Value Engineering Study

KY338 RECONSTRUCTION PROJECT AT I-71/I-75 BOONE COUNTY, KENTUCKY

VE STUDY NUMBER 201206

Draft Report

VALUE ENGINEERING RECOMMENDATION # VE-5
SKETCH OF RECOMMENDED DESIGN

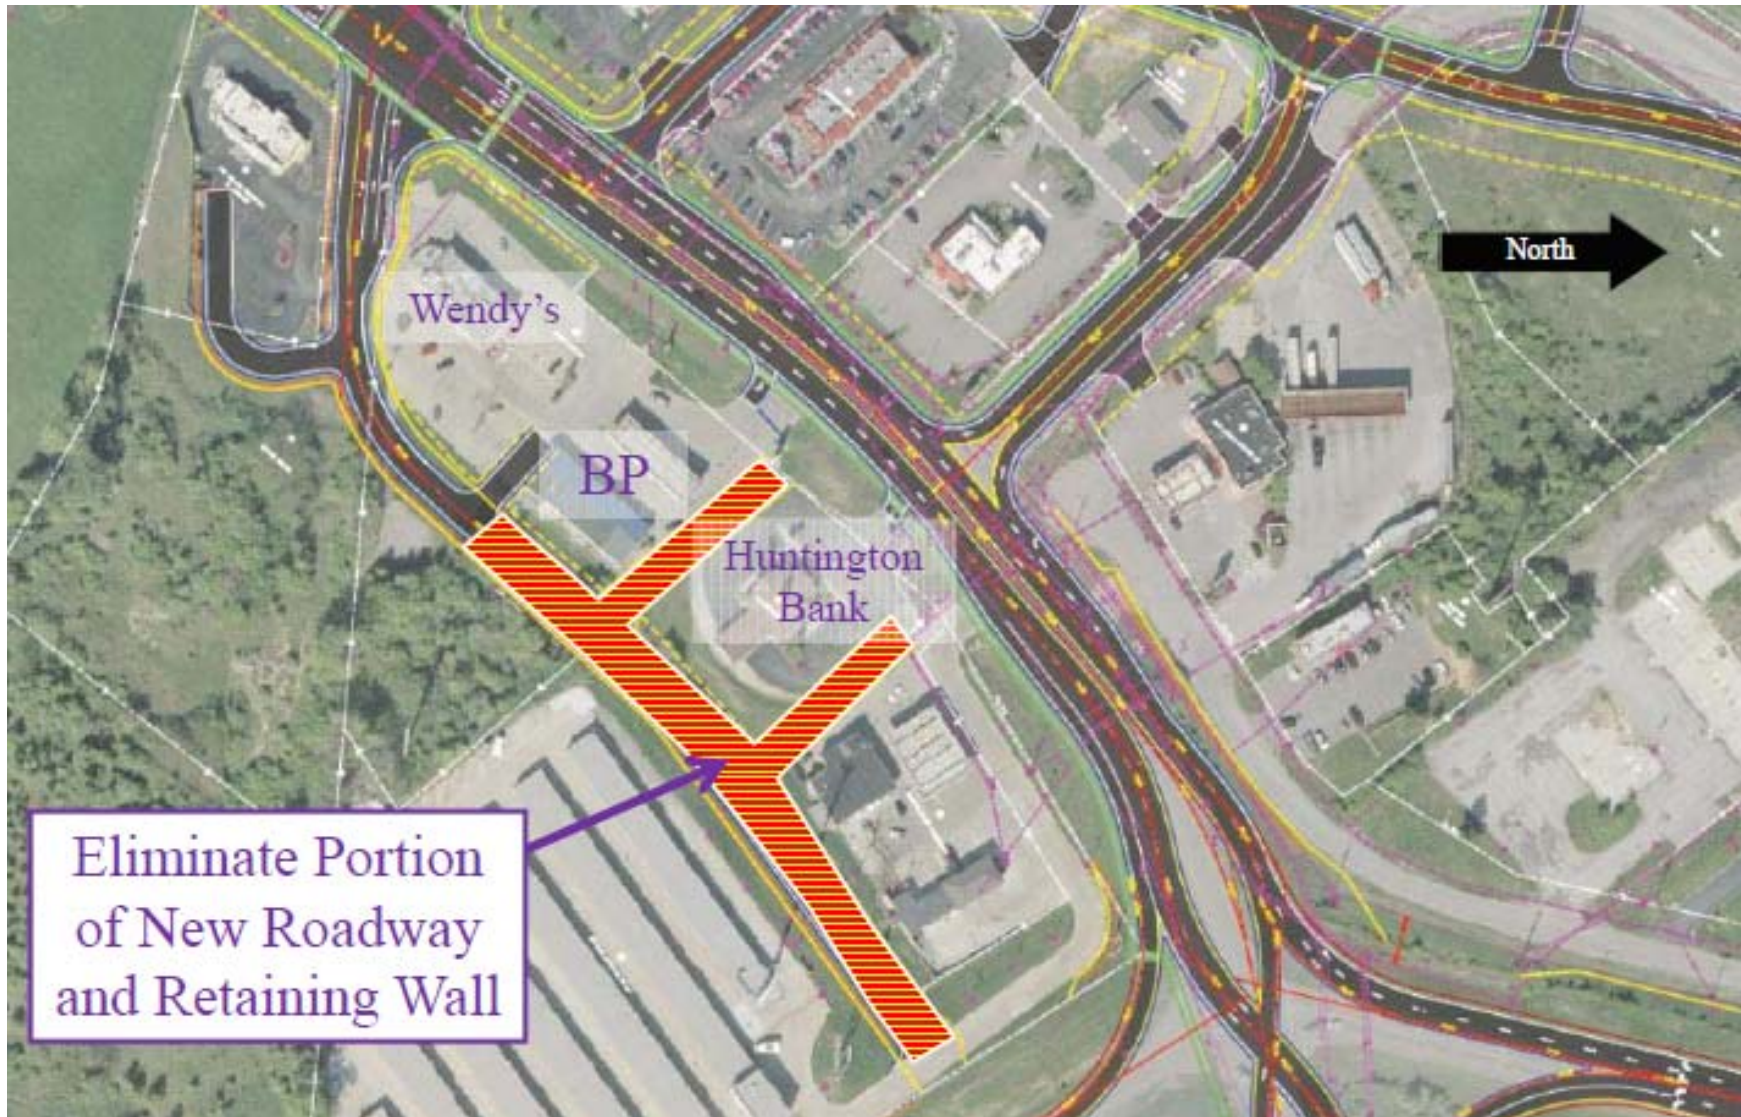
Terminate the backage road at between Wendy’s and BP gas station in lieu of continuing road.

The original design specifies the construction of a backage road from opposite of Paddock Road to the Smart Stop Storage access road. This backage road will provide access to the Wendy’s, BP, Huntington Bank and Shell gas station from behind the properties. It also provides access to the Smart Stop Storage property.

This recommendation is justified as it provides access to the same properties as the original design yet eliminates the need for a retaining wall and additional pavement for the backage road. The original design required right-of-way to construct the backage road. While the recommendation reduces the amount of right-of-way needed to provide access it will not be completely eliminated in the VE recommendation. For this study we considered this as an even exchange with no net change in cost.

The VE Team recommends starting the backage road at Paddock Drive as in the original design but ending it between the Wendy’s and BP Gas Station. Access to the remaining parcels would utilize the existing pavement in front of the properties with modifications as required. This would include purchasing either right-of-way or access easements along the front of the Huntington Bank and Shell gas station.

VALUE ENGINEERING RECOMMENDATION # VE-6
SKETCH OF RECOMMENDED DESIGN

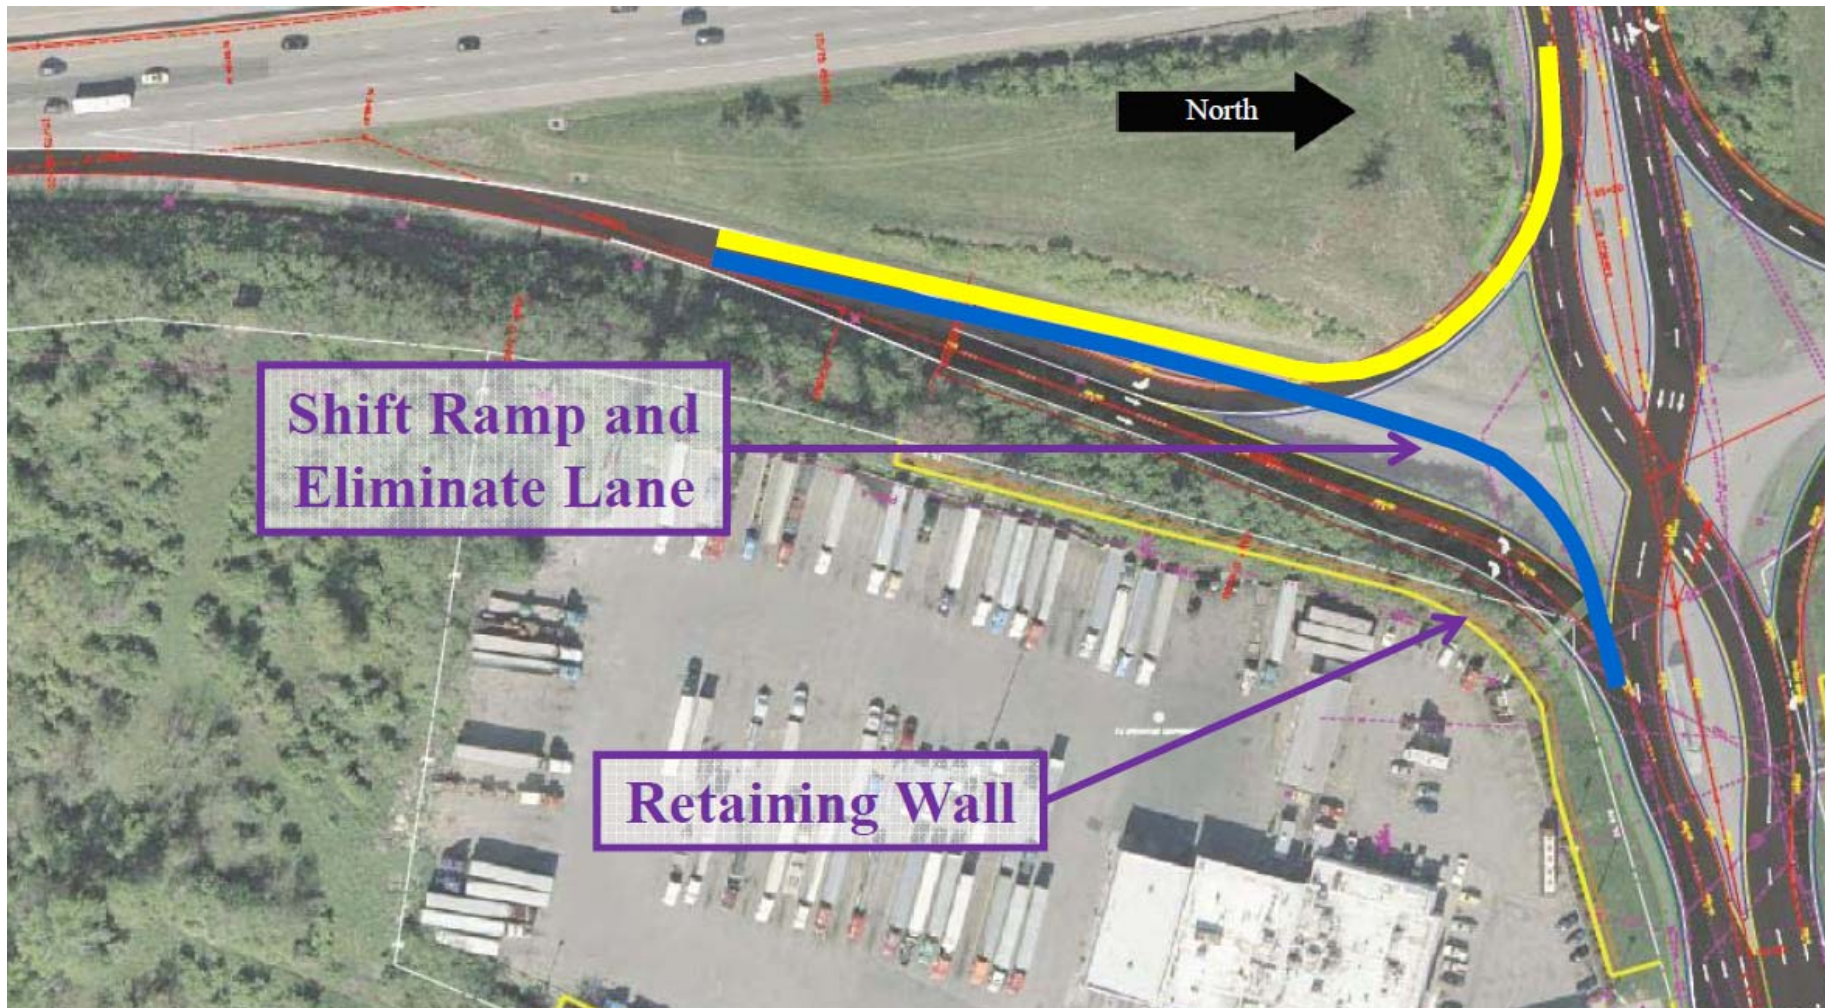
Shift the northbound I-71/I-75 exit ramp westward and construct only one right turn lane to reduce the retaining wall and pavement costs.

The original design specifies the northbound I-71/I-75 off-ramp to KY338 to be located on the east side of the existing ramp with dual right turn lanes to eastbound KY338.

The recommended change is justified as it still meets the purpose and need of the project and provides the same level of service for the interchange. The ramp shift to the west could make the maintenance of traffic (MOT) more difficult however the construction phasing could be developed to make it work. Another option for the MOT could be to close the ramp during off peak times to construct the new ramp. The feasibility of eliminating the wall will need to be judged against the need for additional right-of-way in the southeast quadrant of the interchange where the Travel Center of America truck stop is located.

Additionally, eliminating one of the right turn lanes would not adversely impact the level of service of the ramp. The original design had a v/c=0.42 with dual right turn lanes while the single right turn lane has a v/c=0.46.

The VE Team recommends shifting the ramp widening to the west of the existing ramp to avoid the need for a retaining wall. The current layout helps with the maintenance of traffic operation but requires the construction of a 15 feet high retaining wall next to the Travel Centers of America truck stop. This would require a reconfiguration of the ramp terminus with the KY338 thereby modifying the layout of the Double Crossover Diamond interchange. The other recommendation would eliminate one of the right turn lanes from northbound I-71/I-75 to eastbound KY338.

VALUE ENGINEERING DESIGN COMMENT # VE-7
SKETCH OF RECOMMENDED DESIGN

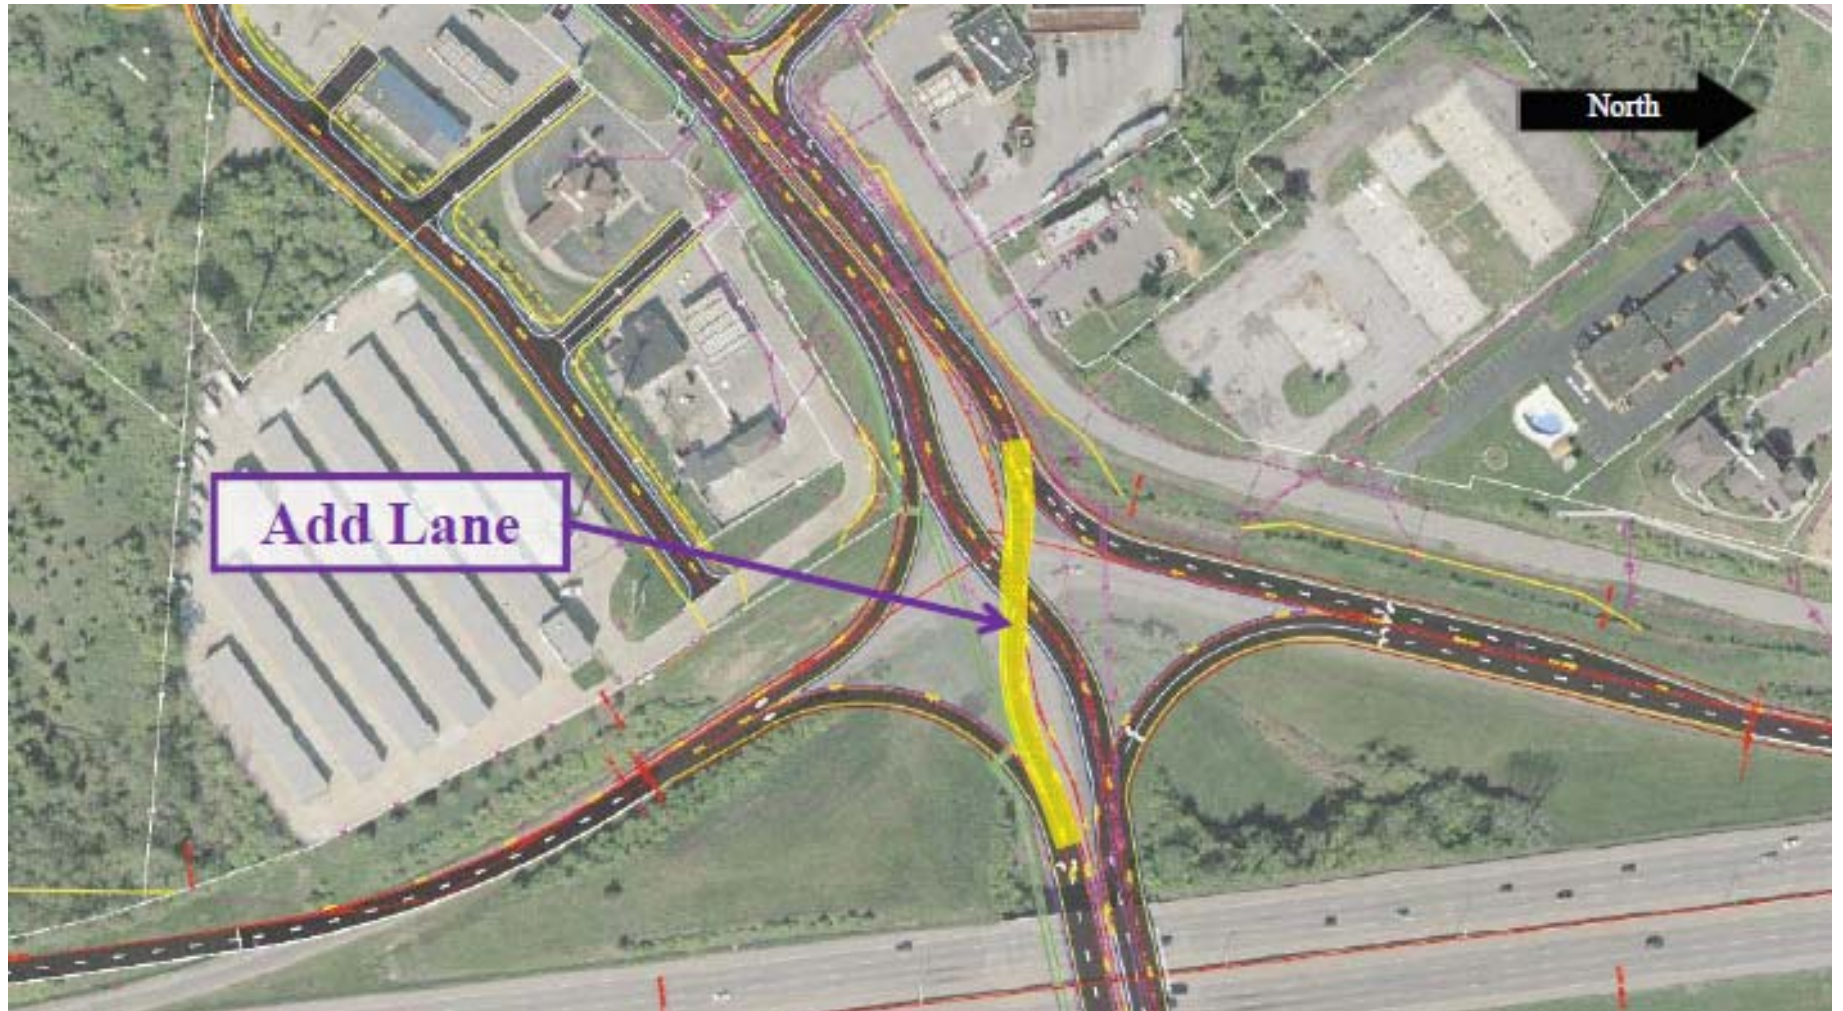
Utilize two westbound lanes through the DCD interchange in lieu of only one westbound lane.

The proposed configuration utilizes 2 westbound through lanes approaching the interchange; at the interchange the outer lane is dropper as a left turn lane and a single lane continues through the interchange. While this design meets capacity requirements for all movements, it does not provide a continuous basic number of lanes through the interchange and will cause a merging point within the DCD. This will also complicate signing on the approach of the DCD to warn drivers of the lane drop. The short maneuvering distance between the DCD and the Best Pal Drive and US25 interchanges will also make it difficult for vehicles to merge into the appropriate lane.

It is proposed to carry the outer westbound lane through the interchange, which will serve both left turn and through traffic. This configuration will eliminate the need for the upstream merge approaching the interchange while still providing more than adequate capacity for the westbound to southbound left turn movements. In addition, providing 2 westbound through lanes at the southbound ramp terminus will reduce the critical volume at the intersection, improving operations.

Figure 10-53A2 of the AASHTO Green Book (see page 20-78)

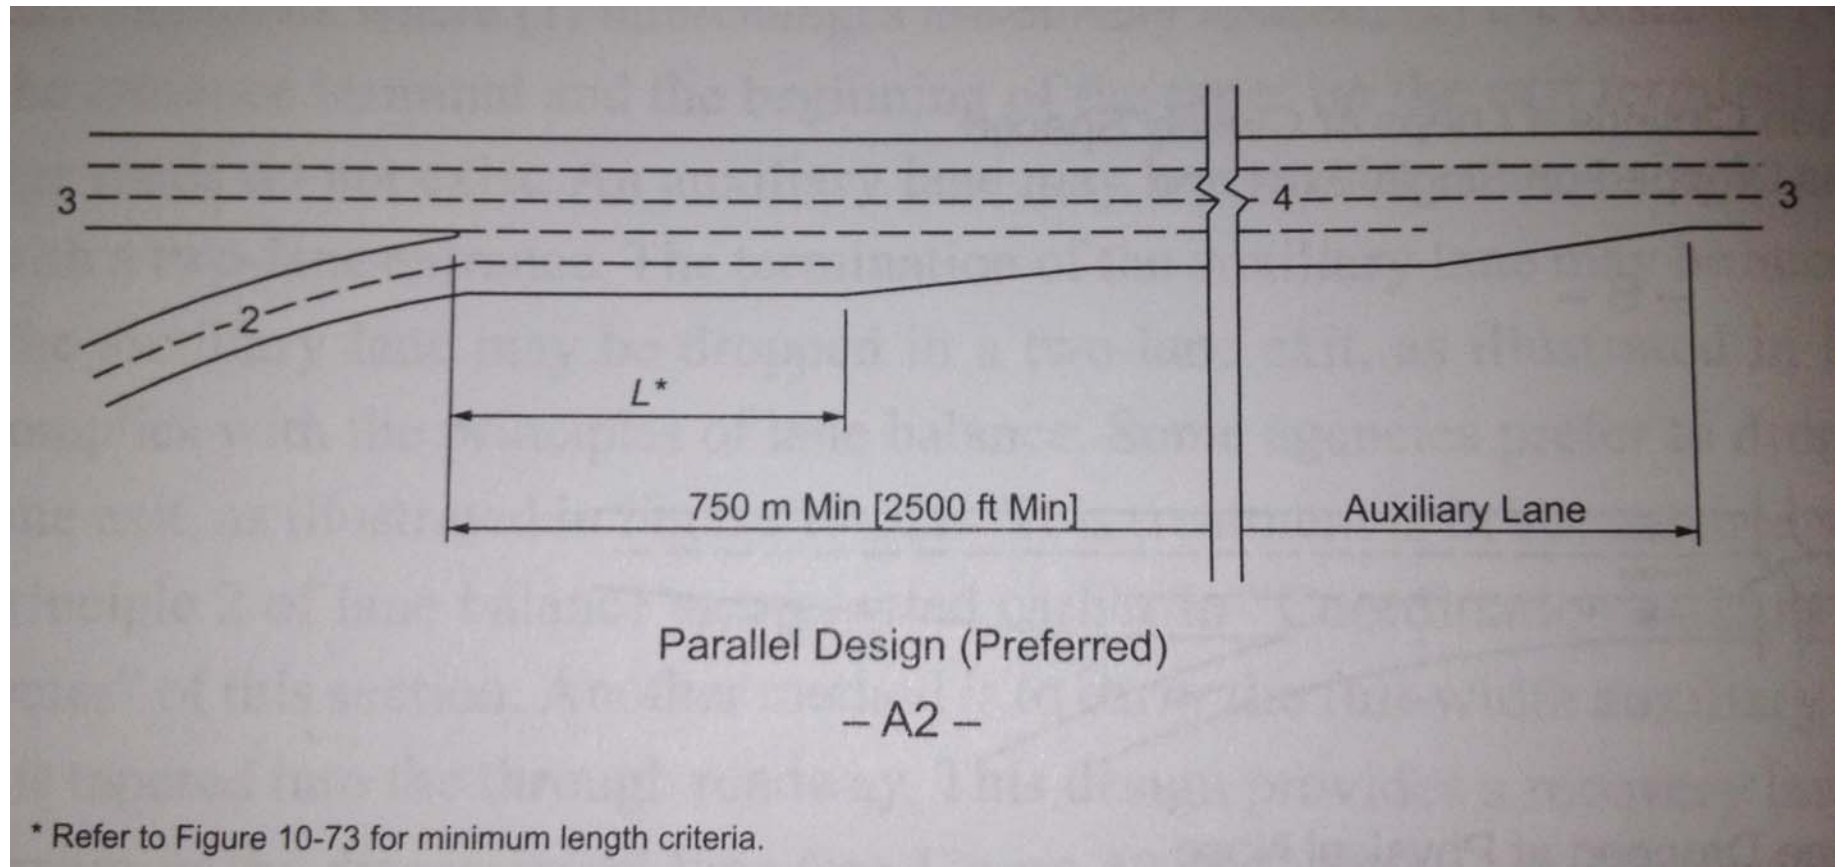
Utilize properly sized entrance and exit ramps in lieu of continuous auxiliary lanes on I-71/I-75 north of KY338 and long ramps to the south of KY338.

Review of the IJS and capacity analysis indicates that a reduced length of the auxiliary lane length will more than adequately meet the on-off ramp requirements. The HCS analysis presented in the IJS report prepared by HNTB assumed only a 1,000 foot deceleration/acceleration length ($L_{A1} = 500$; $L_{A2} = 500$) for the northbound on/off-ramps and reports a LOS C for all merge/diverge areas. Shortening the auxiliary lanes or deferring their implementation until a later date will save considerable cost by reducing 50 percent of the auxiliary turn lane length and eliminating the need for improvements of the Frogtown Road underpass.

- Deferring the southbound auxiliary lane improvement to a later date and providing a reduced length (2,500 ft) of auxiliary lane approaching the KY338 southbound exit consistent with figure 10-53B1 of the AASHTO Green Book (see page 10-78)
- Deferring the northbound auxiliary lane improvement to a later date and providing a reduced auxiliary lane length of 2500 ft north of KY338 consistent with Figure 10-53A2 of the AASHTO Green Book (see page 20-78)
- Maintains existing design for southbound I-71/I-75 On-Ramp

VALUE ENGINEERING RECOMMENDATION # VE-10

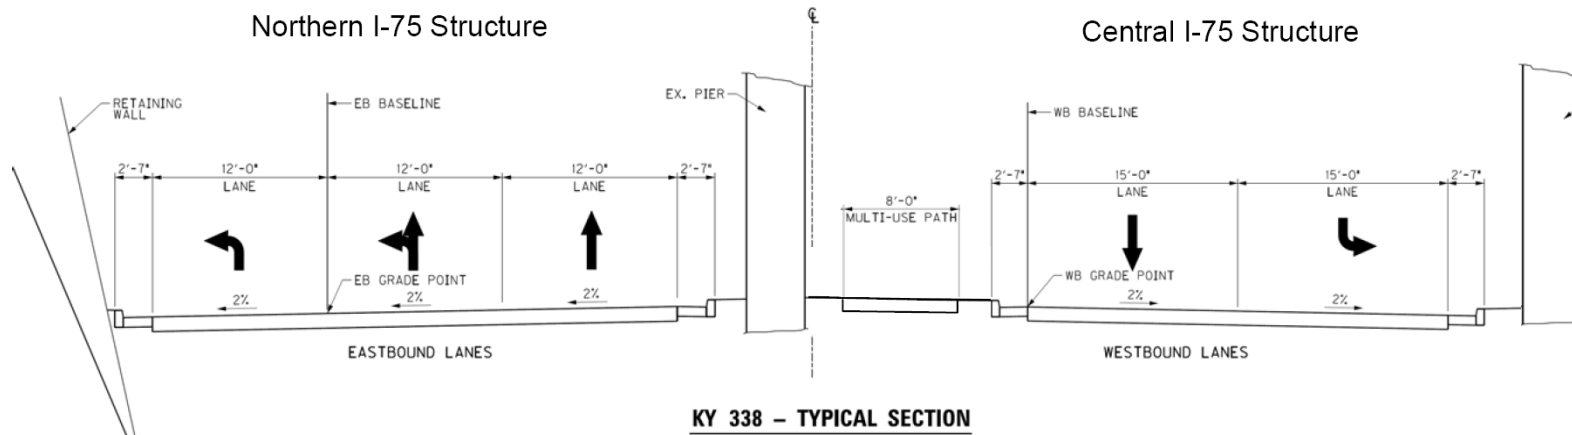
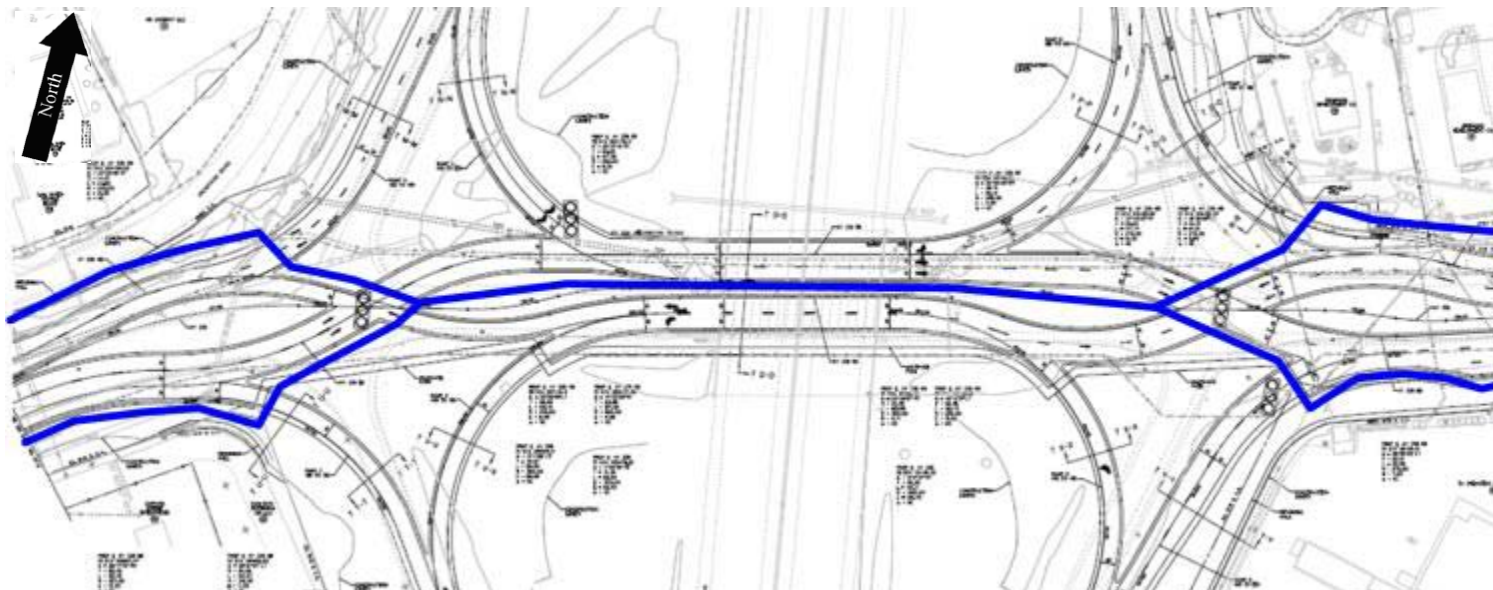
The original design requires excavation and a retaining wall under the south span to allow for the shared use path. There are two primary benefits to this modification. First, there is a cost savings because there would be no need to do any construction under the south span. Second, by putting the path in the center between the eastbound and westbound lanes, crossings can occur at the interchange signals, thus allowing pedestrian and bike facilities on both sides of the road just past the signals. Pedestrians can then travel shorter distances to their destinations instead of traveling to the first signalized intersection to make the crossing legally. This is especially helpful on the west side of the interchange where the preferred alternate's first signal is a quarter mile away from the interchange.

The VE Team recommends shifting the westbound travel lanes to the south underneath the central span so that the shared use path can then be added adjacent to the travel lanes.
